STAFF REPORT

DATE: MARCH 2, 2026
TO: PLANNING COMMISSION
FROM: KATRINA KAWAGOE, SENIOR PLANNER
SUBJECT: PLANNING APPLICATION NO. 260013
APPLICANT: REIKO MICHLIG, REIKO ARCHITECTURE
LOCATION: 3554 LARIAT LANE

A request for a Neighborhood Compatibility Determination (NC-260014) for an interior remodel and additions to an existing two-story, single-family residence that includes 474 SF of first story additions and a 570 SF second story addition; and a Variance (V-260015) to exceed the required height to setback ratio in the west side yard.

Figure 1: Proposed site plan

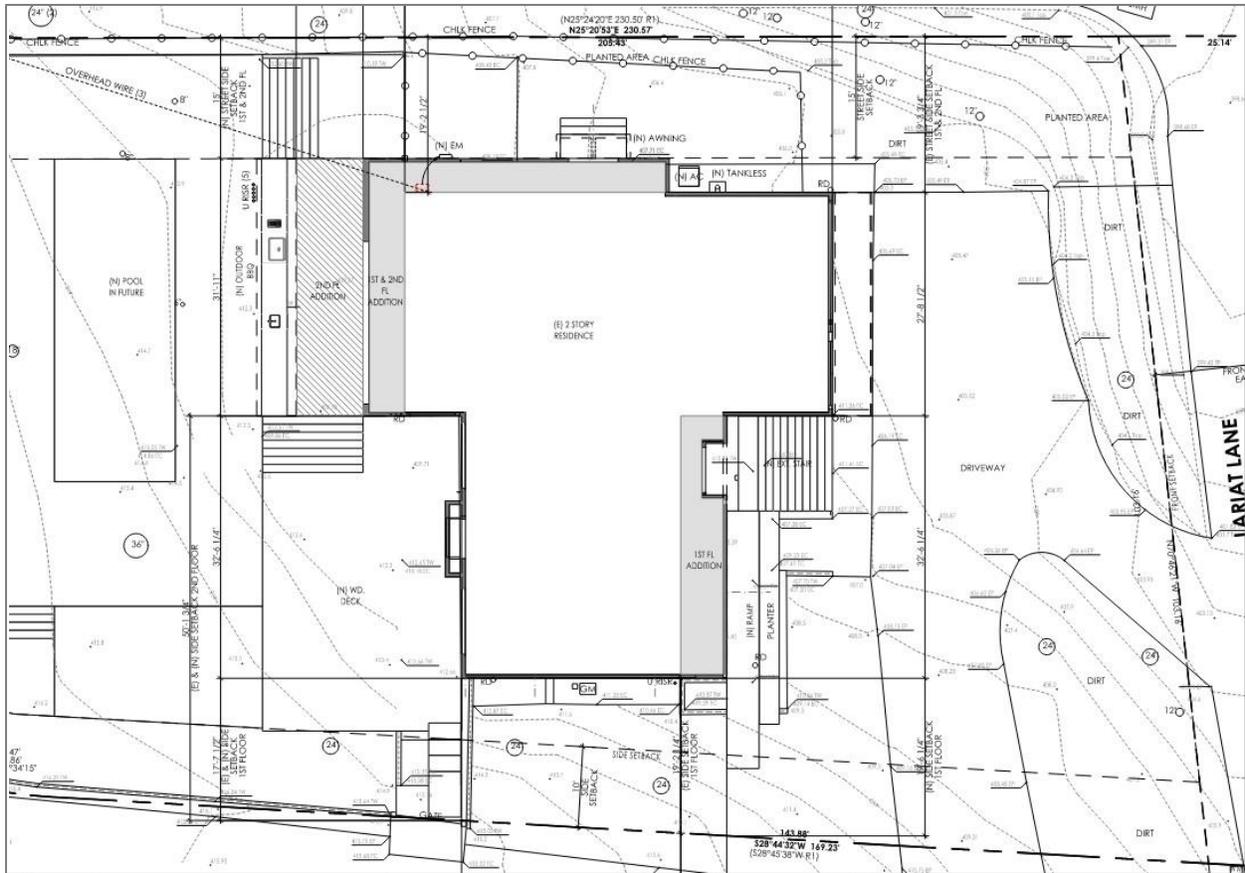
While the project complies with the maximum building height of 27' and the required 15' street-facing side yard setback, the vertical massing of the addition does not meet the height-to-setback ratio, outlined in RHEMC Section 17.06.180, which requires that portions of structures over 14' in height to be set back an additional foot for every foot of additional height. Because the proposed two-story addition exceeds the height-to-setback ratio along the west side yard, the applicant is requesting a Variance to permit the encroachment.
